Re: Facility Relocation Sprinkler Evaluation
Puyallup Corporate Park
2504 East Main
Puyallup, WA 98372

The scope of this project was for Veltre Engineering to evaluate as a tenant improvement the ability of the existing sprinkler system at RedDot Corporation's new facility to provide an acceptable discharge to protect their current operations. The evaluation includes the impact of the new racking system on the sprinkler performance. The existing facility at 495 Andover Parks East, Tukwila, WA was visited on November 15, 2022, to identify activities, storage arrangements, and commodity classifications. Additionally, the new facility at 2504 East Main Avenue, Puyallup, WA was visited to verify that the primary components of the system that will impact the hydraulic capacity (pump data and size of mains and branch lines) was installed in accordance with the as-built drawings dated 2/9/2022. This evaluation assumes the installation has been accepted by the authority having jurisdiction (AHJ) for Puyallup as a warehouse to be leased based on the design criteria stated in the as-built drawings. The criteria applied in this evaluation is the Washington Building Code (2018 IBC and IFC wit

Picture 14 – Combustible Obstructed Ceiling

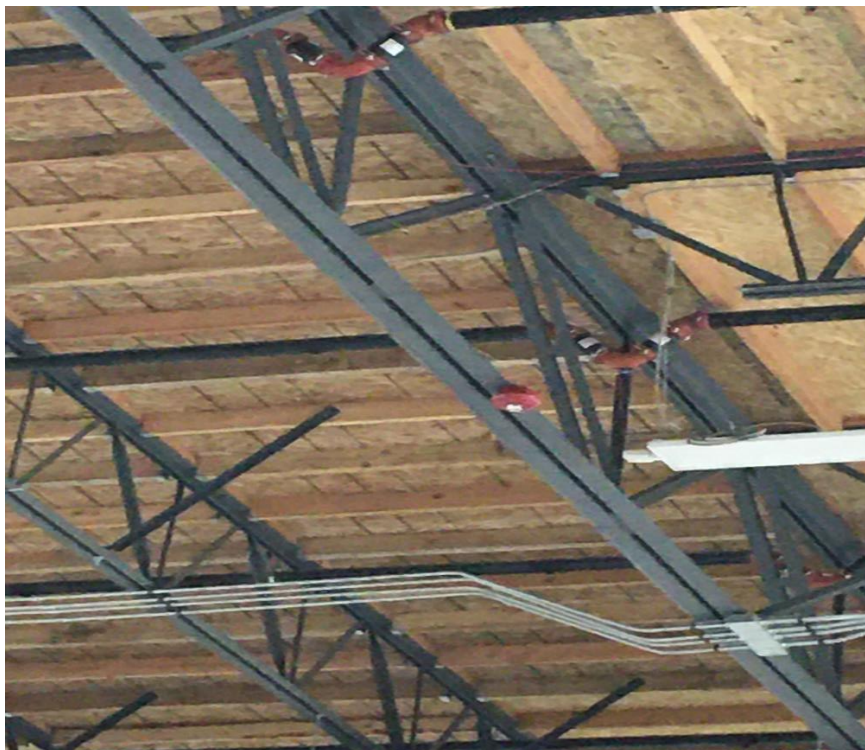
The new facility has a floor plan of 199,225 sf, a maximum ceiling height of 38'4", and a ceiling slope less than 2 in 12. The ceiling consists of plywood with 2x6 joists on 2 ft center classified as combustible obstructed combustion (see picture 14). The wood joists are supported by 2 ft and 3 ft metal trusses with steel columns (without fireproofing) throughout the floor area (see picture 15). The same occupancies groups and functions will apply.

The ceiling is combustibile obstructed construction. NFPA 13, 2016 edition does not allow ESFR sprinkler with this type of construction (see NFPA 13, paragraph 8.4.6.3 and Table 8.12.2.2.1). This restriction was unnecessarily conservative and was deleted in the 2019 edition (see NFPA 13, paragraph 14.2.4). Note the Table was not corrected until the 2022 edition. Veltre Engineering considers the use of ESFR sprinklers to be acceptable.

No action required.

Picture 15 – Columns

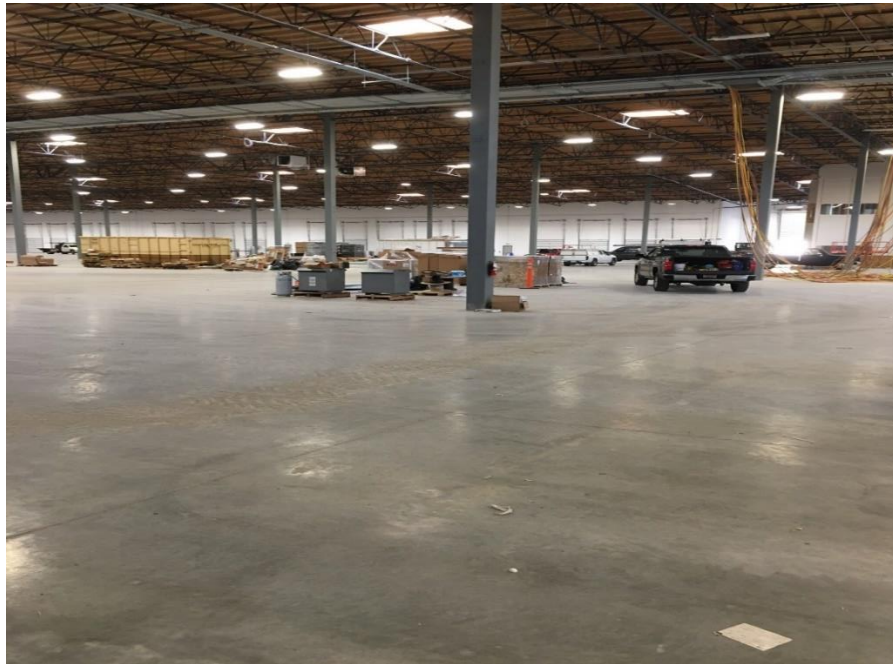
When building columns are not provided with fireproofing and located within the footprint of racks for storage heights greater than 15 ft, they are typically required to be protected. There are a couple of exceptions to this requirement one of which is the use of ESFR sprinklers (see NFPA 13 paragraph 17.1.4.1(4)). As such, column protection is not required.

No action required.

Picture 17 – Hydraulic Data Sign

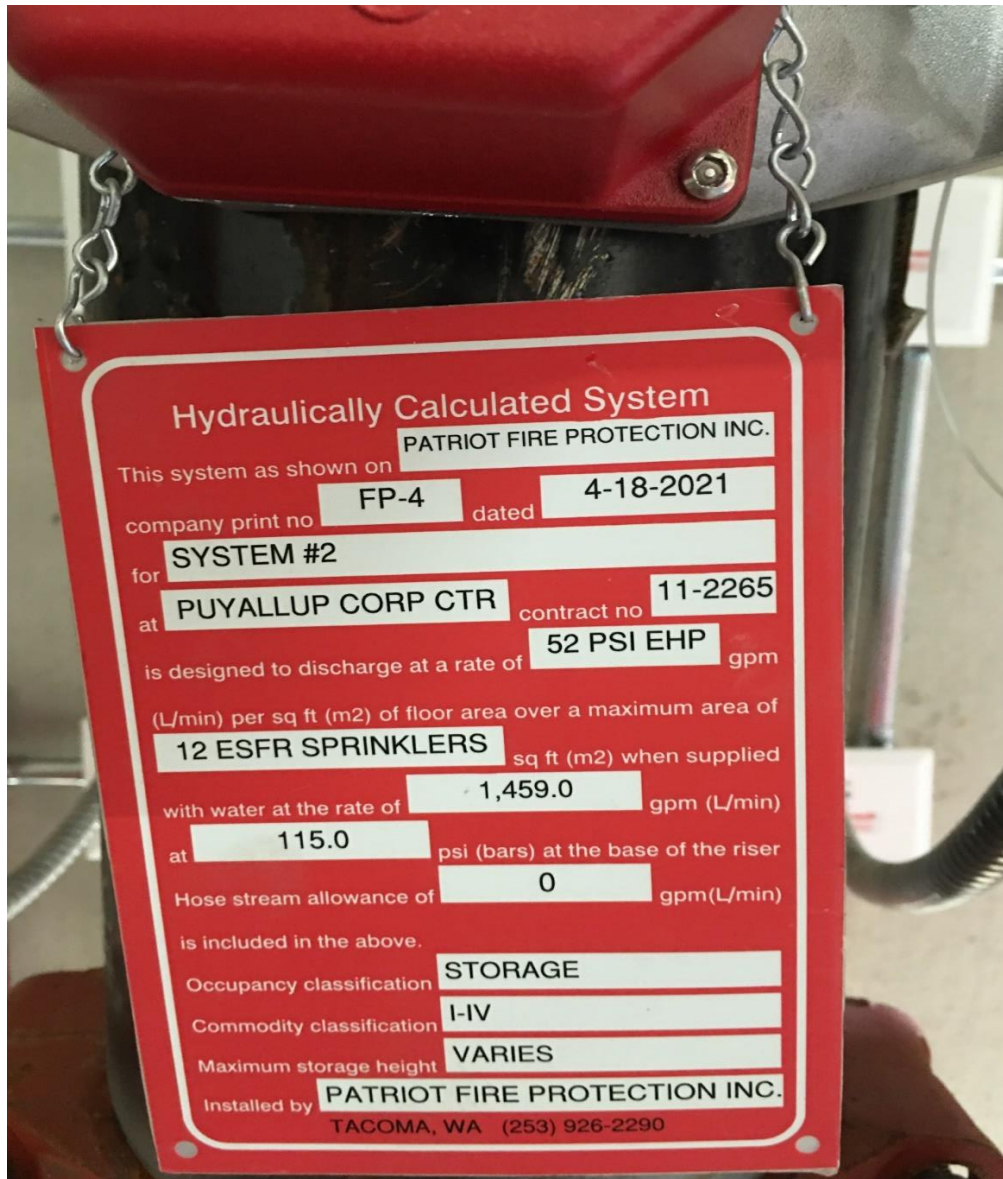
Based on the hydraulic data sign, the typical system demand at the base of the riser (without hose demand is 1,459 gpm at 115 psi (see picture 17). The associated hydraulic calculations were not available with the as-builts drawings.

There were no hydraulic calculations submitted with the as-built drawings. The hydraulic data signs indicates a typical demand at the base of the riser to be 1,459 gpm at 115 psi. Veltre Engineering performed a supplemental hydraulic calculation and found the demand at the base of the riser to be 1,468 gpm at 117 psi (see Appendix B).

No action required.

Figure A – Temperature Ratings Near Unit Heaters

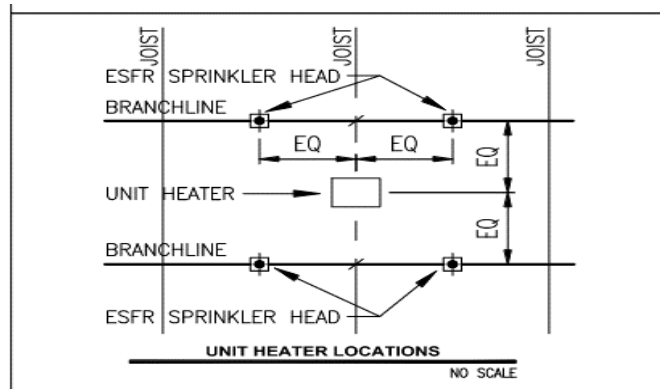
The sprinkler as-built drawings have identified that the sprinklers immediately adjacent to the ceiling unit heaters have an intermediate temperature rating (see Figure A) as required by NFPA 13, paragraph 9.4.2.5. The requirement for intermediate rated sprinklers extends 20 ft out discharge side of the unit

heater in a pie shape area based on a 30-degree angle out from the corner of the unit heater. This would pick-up two to four sprinklers on the next branch line. The second branch line is note addressed on the as-builts. The installing contractor should verify the temperature rating complies with NFPA 13 and update the as-built drawings to reflect it. If sprinklers with an ordinary temperature rating have been installed on the second branch line, the heater discharge could inadvertently activate the sprinklers.
